ADDENDUM NO. 1

**TITLE: BOONE CENTRAL POST TENSION TRACK AND FOOTBALL FIELD PROJECT
BOONE CENTRAL PUBLIC SCHOOLS**

PROJECT: REGA NO. 121271

DATE OF ISSUE: March 22, 2013

MISCELLANEOUS DETAILS

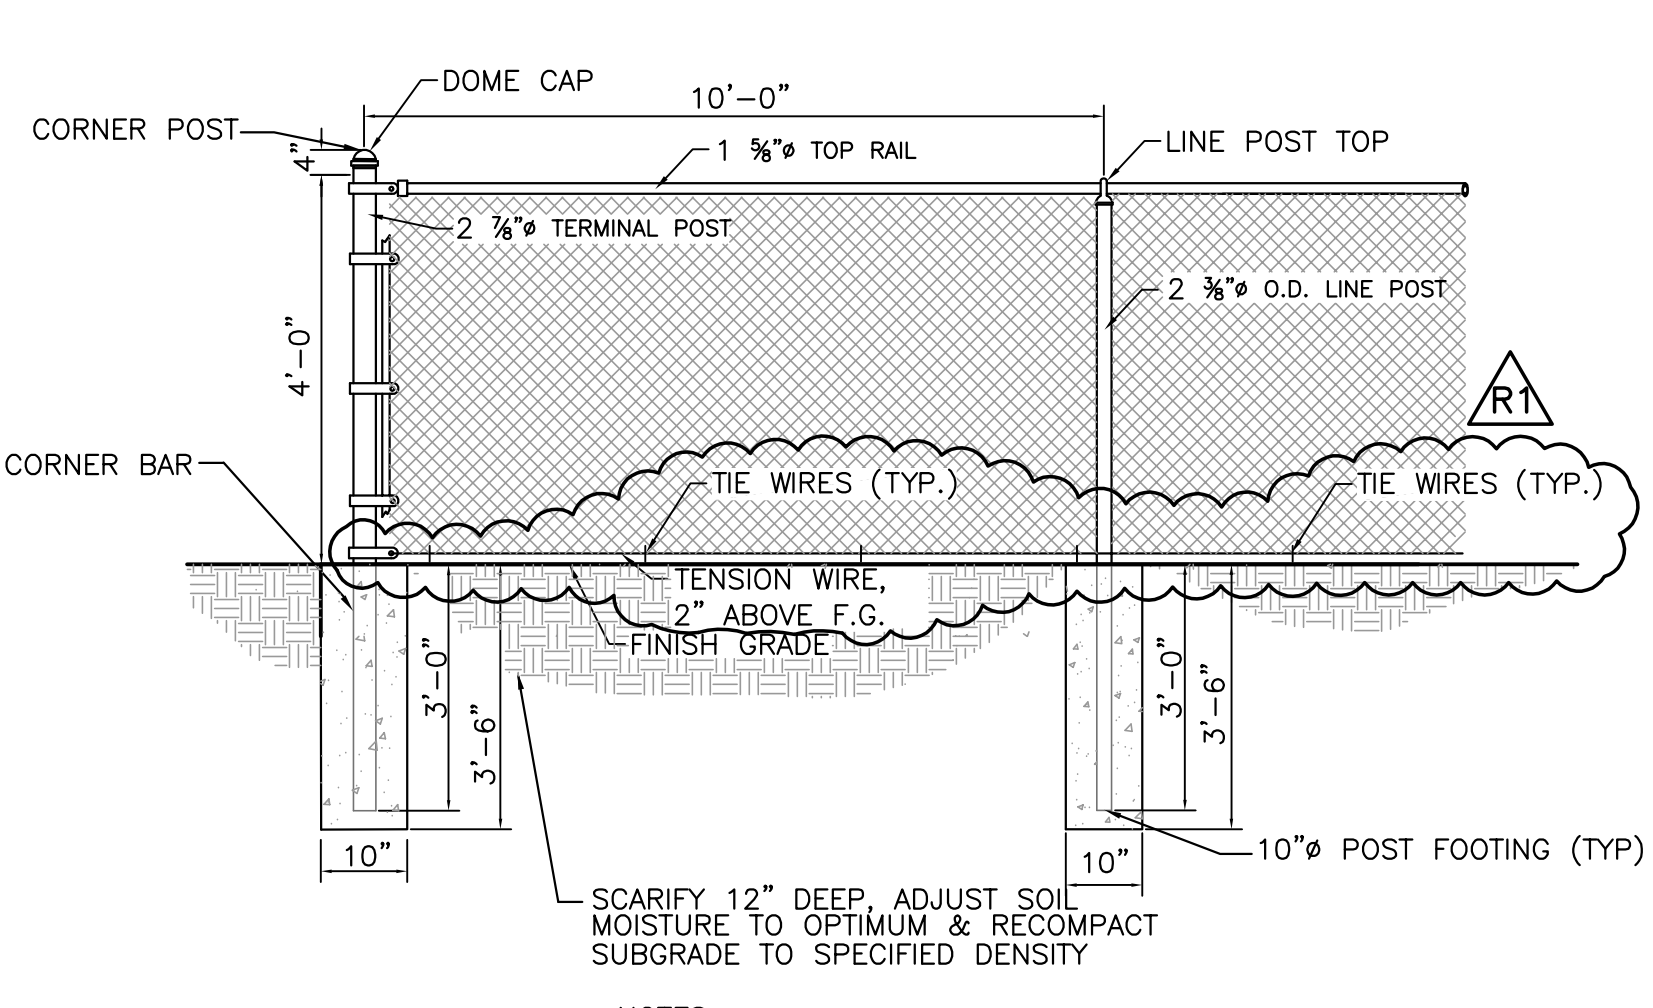
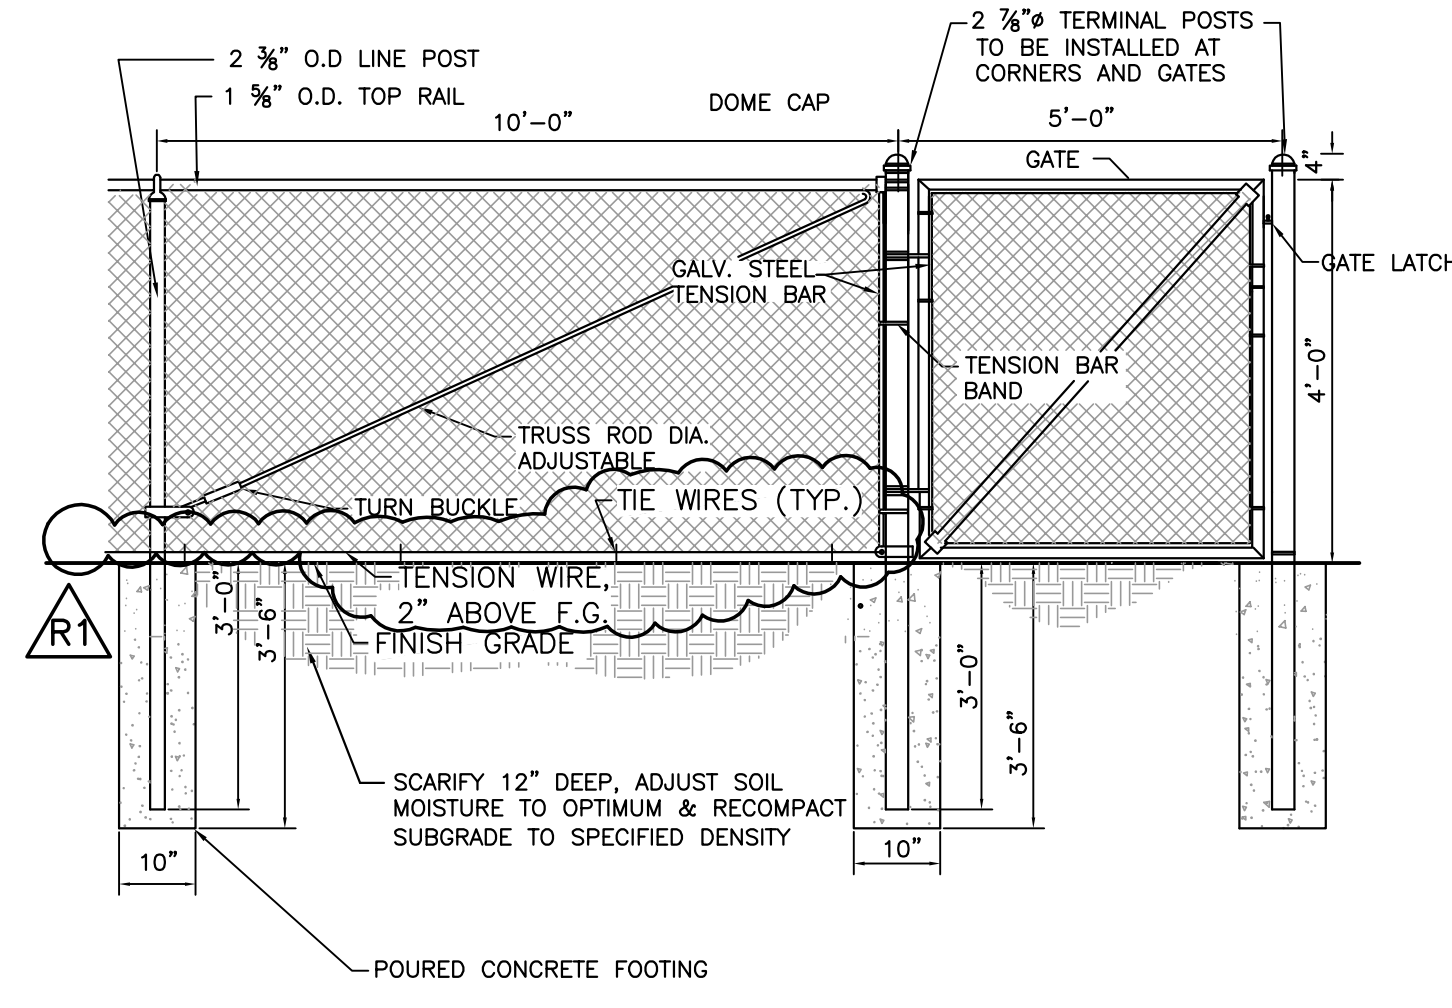
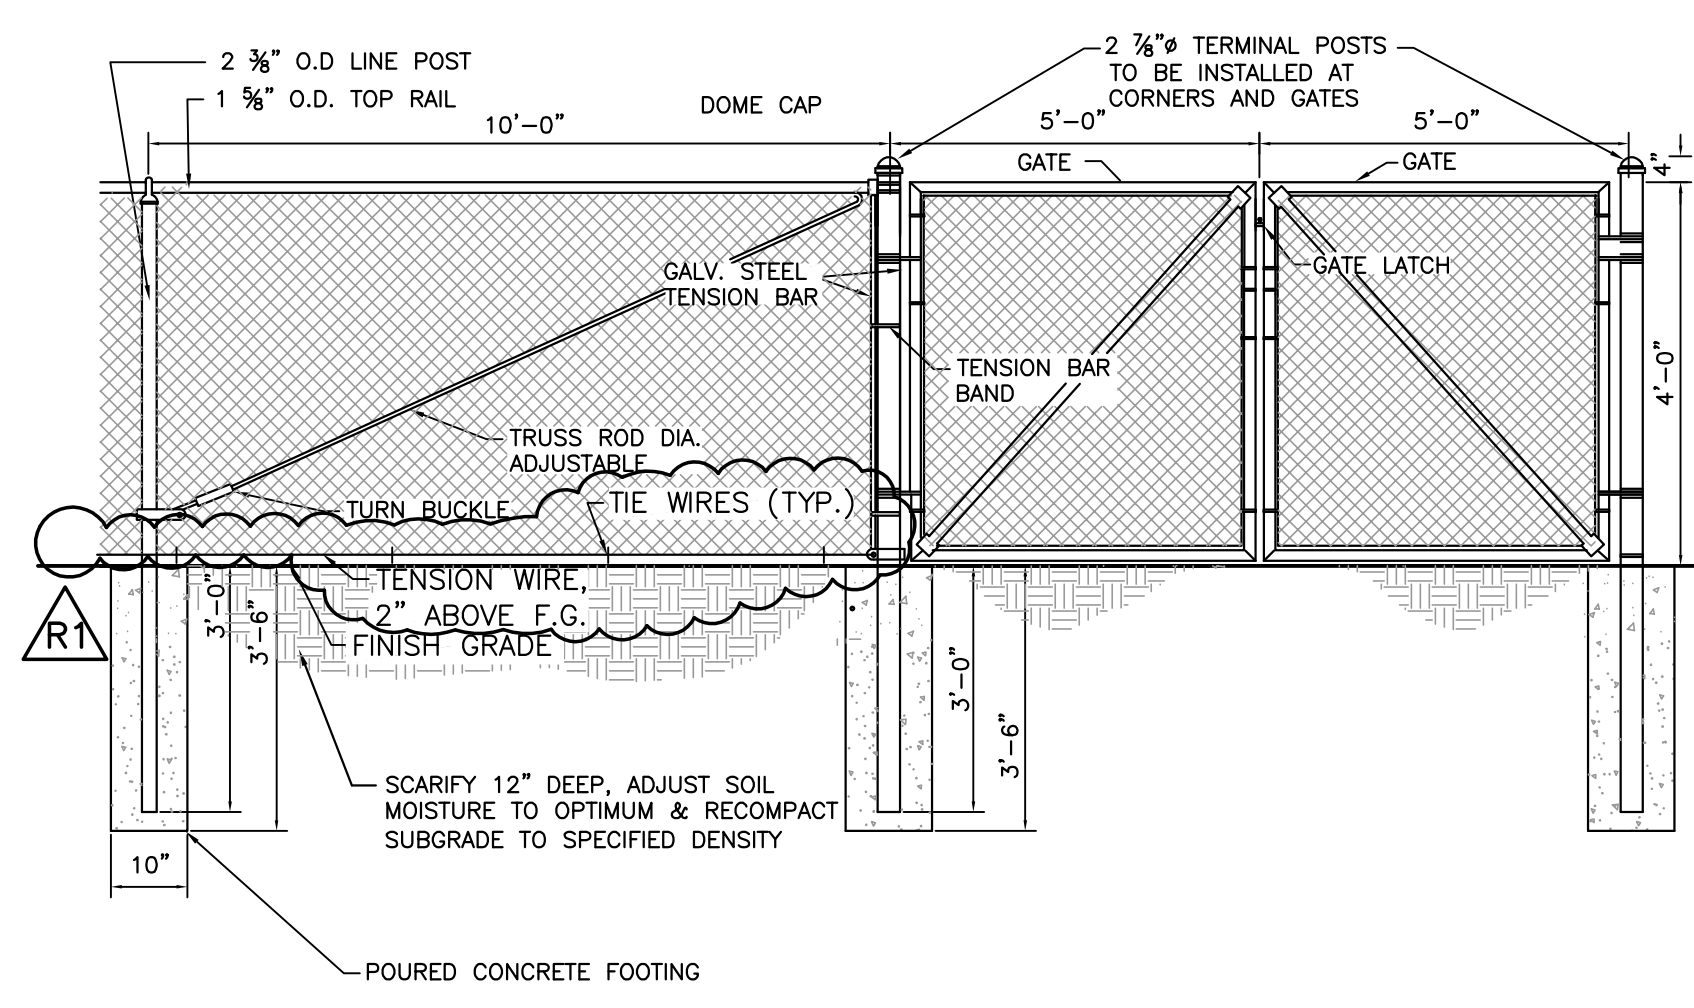
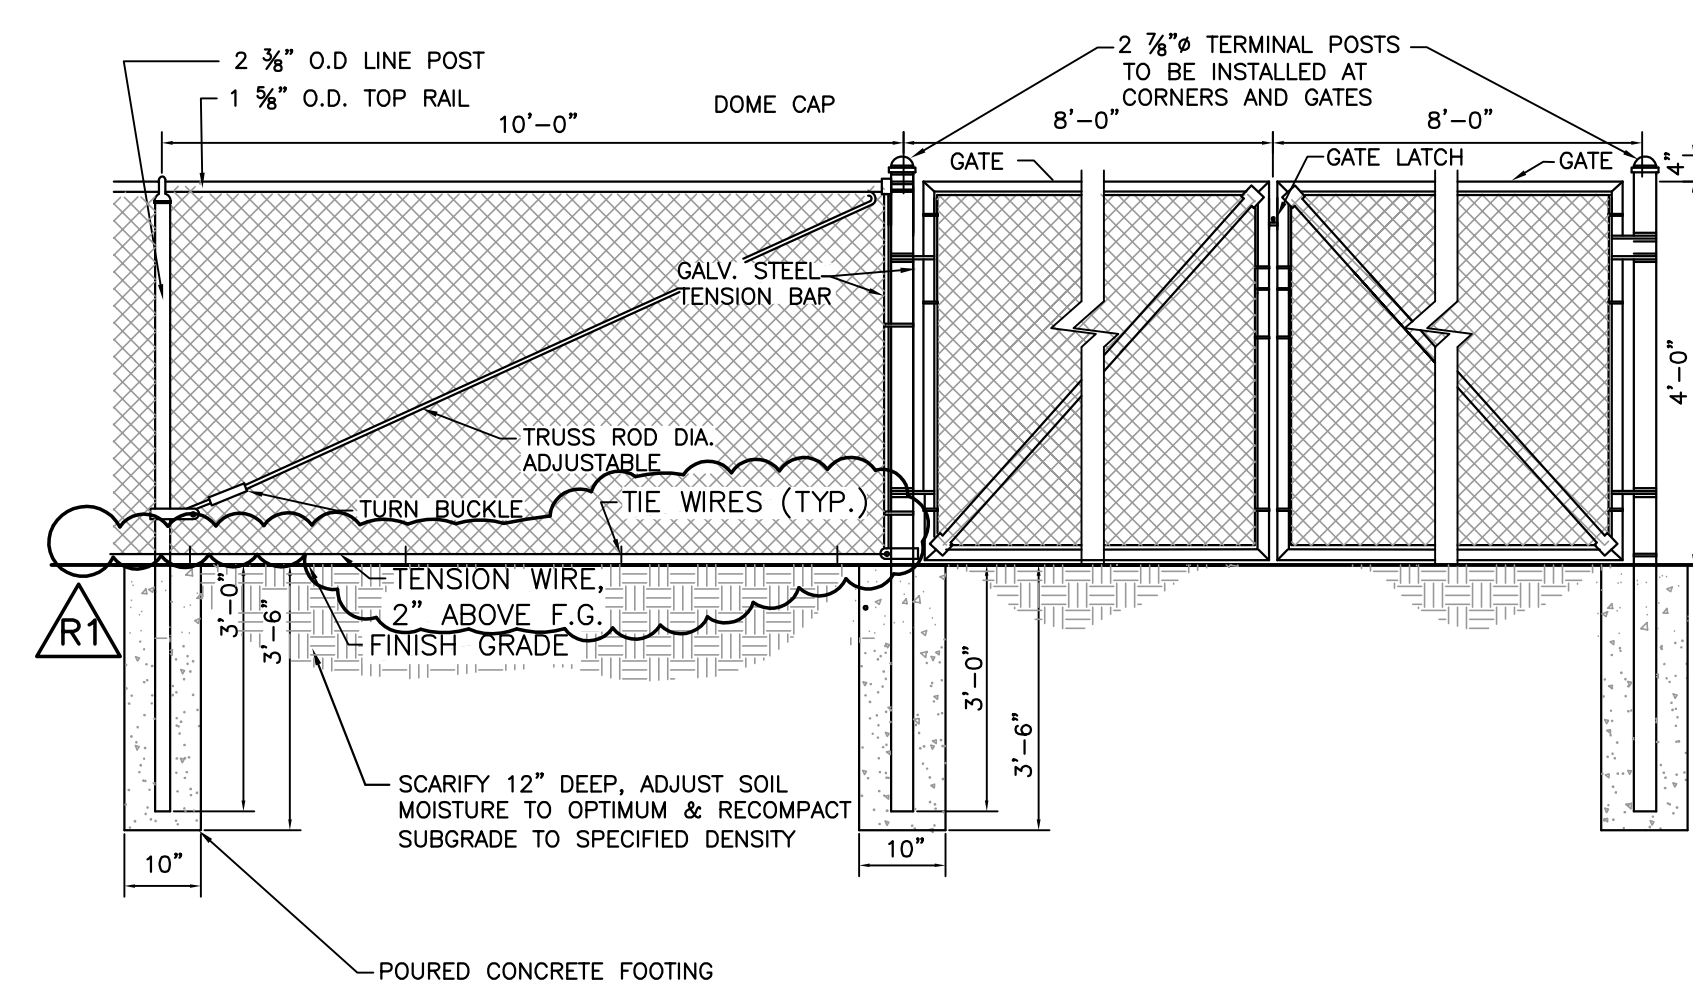
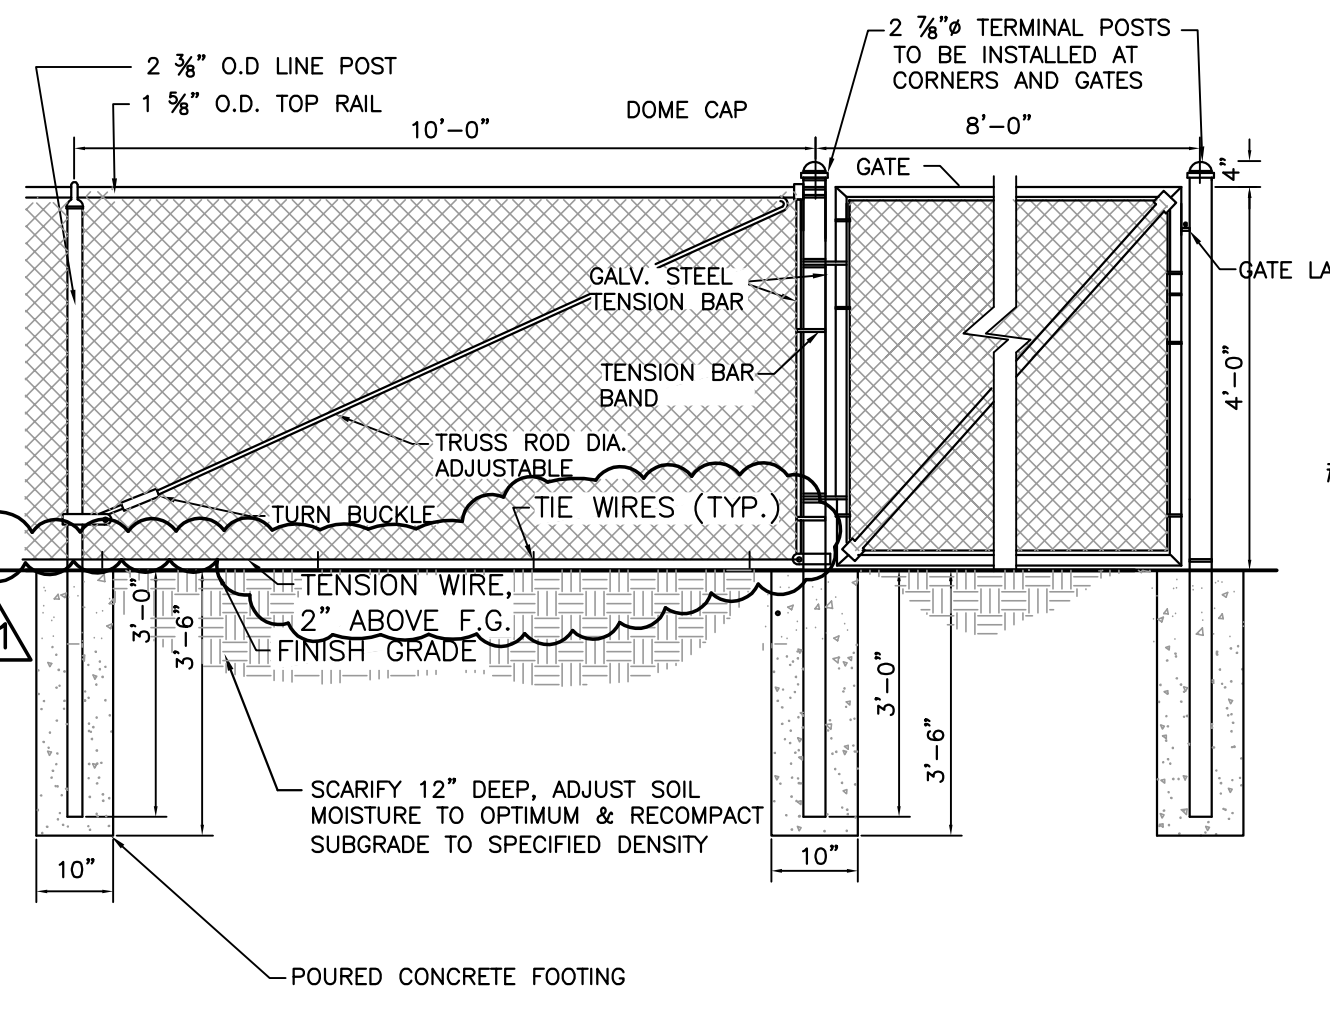
Delete: 2 inch bottom rail on all details

Add: Tension wire on bottom of chain link fence on all details
